# UNITED STATES PATENT AND TRADEMARK OFFICE

APPLICATION NO.	FILING DATE	FIRST NAMED INVENTOR	ATTORNEY DOCKET NO.	CONFIRMATION NO.
08/851,465	05/05/1997	EDGAR C. ROBINSON	INT21246	5986

<b>Office Action Summary</b>	<b>Application No.</b> 08/851,465	<b>Applicant(s)</b> ROBINSON ET AL.	
	<b>Examiner</b> SARAH SUERETH	<b>Art Unit</b> 3749

**Segment of Fig. 1 of Nutten** (the examiner has added the lead arrows and text appearing below).

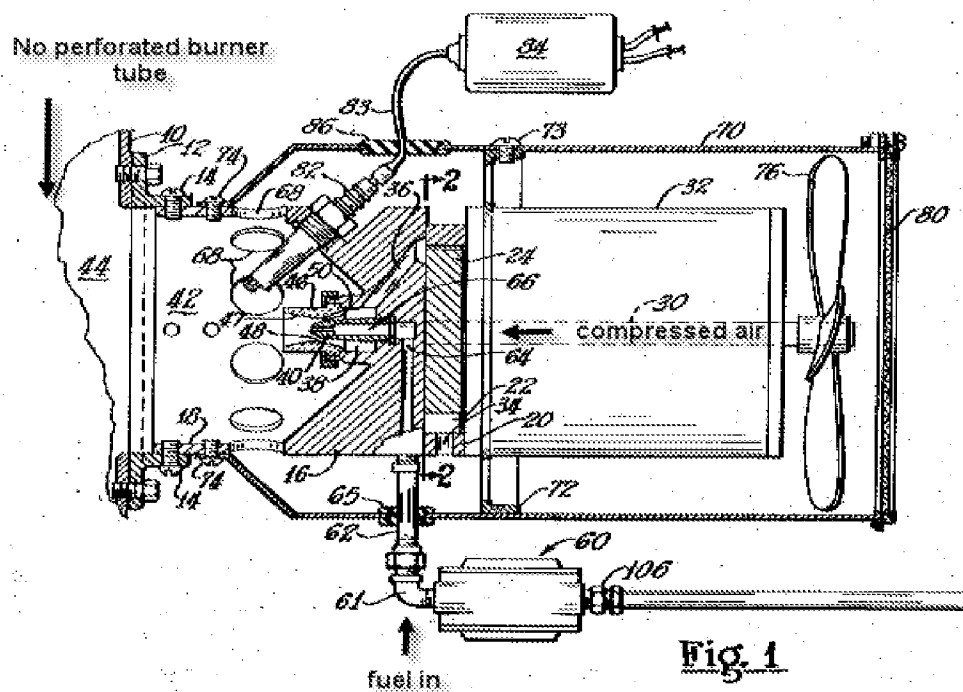
As discussed and above and illustrated in the segments of applicant's Fig. 5A and Nutten's Fig. 1, Nutten discloses all the elements of applicant's claim 1 with the exception of a burner tube with a perforated outer surface rendering the burner an "infrared burner." However, the examiner has pointed to Patrick showing the use of a perforated burner tube in the burner art forming an "infrared burner." The following is a segment of Fig. 7 of Patrick which is disclosed as being an infrared liquid fuel burner (next page):

**Rotated Copy of Applicant's Fig. 5A** (the examiner has added the lead arrow and "perforated burner tube" text appearing below).

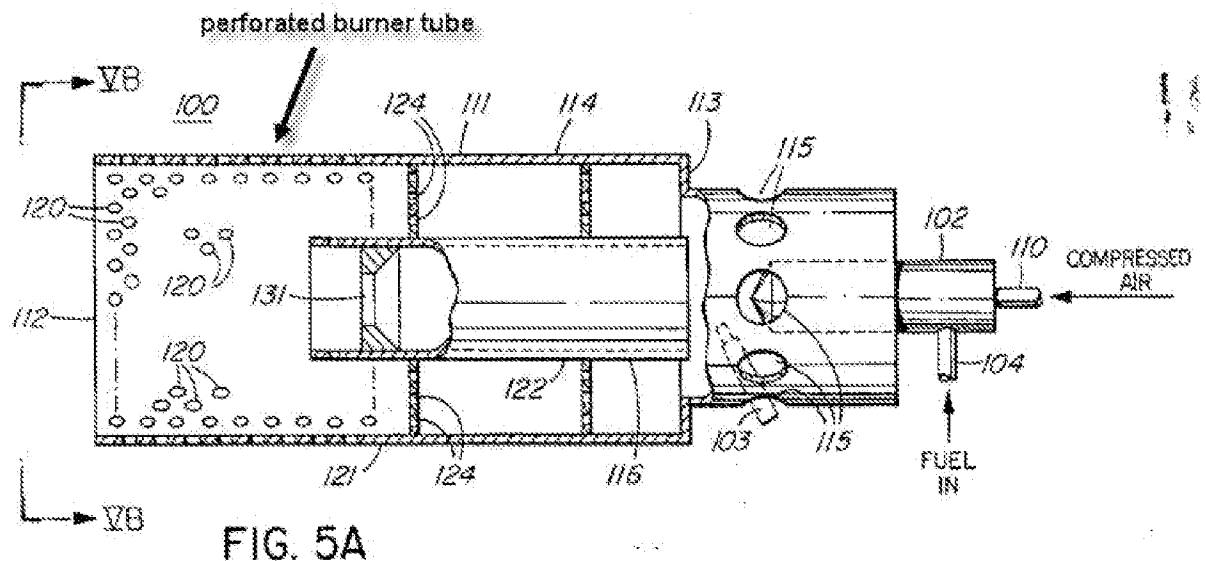
3. Claims 1-8 are rejected under 35 U.S.C. 112, first paragraph, because the specification, while being enabling for the teaching of a perforated burner tube downstream of the nozzle, does not reasonably provide enablement for the limitation that the perforations are located "immediately adjacent" the nozzle. Figure 5A, for example, shows perforations (120) at a distance spaced from the nozzle (102). The specification does not enable any person skilled in the art to which it pertains, or with

6. As discussed above, claim 1 has been amended to include the recitation of perforations which are located "immediately adjacent" the nozzle. However, it is unclear from the claim if the perforations are intended to be the openings shown in the sides of the burner tube (120), the perforations in spacer plates (124), or the perforations supplying air to the nozzle (115).

7. For Examination purposes, the examiner has regarded the claims as referring to the perforations in the sidewalls of the burner tube (120), but applicant is requested to clarify if the claim is intended to read on the perforations in the sideways spacing plates (124) or at the nozzle outlet (115).

**Segment of Fig. 7 of Patrick** (the examiner has added the lead arrow and text appearing below).

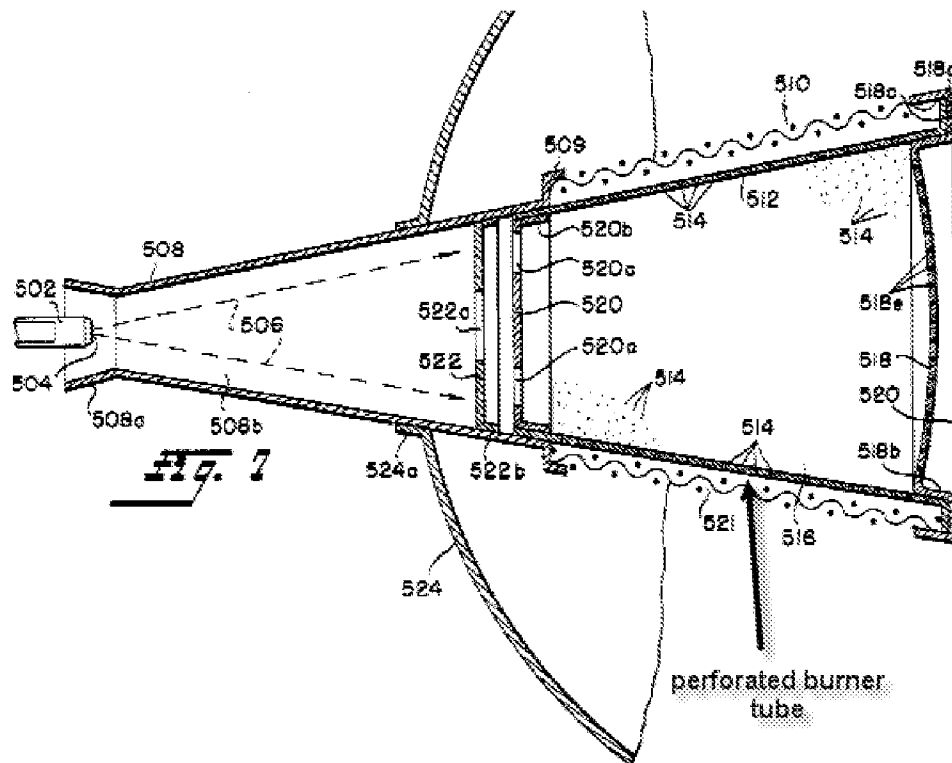
As seen in the above Figures, and noted in the above 112 rejections, the scope of the new claim limitation that the burner tube has perforations extending immediately adjacent the nozzle is unclear. However, Patrick is regarded to teach this limitation, as Patrick shows a liquid fuel nozzle (502) upstream of a perforated burner tube (514). To the extent the perforated burner tube of applicant is “immediately adjacent” the fuel nozzle, the Patrick burner tube is regarded as being “immediately adjacent” to the nozzle, as they show the same configuration.
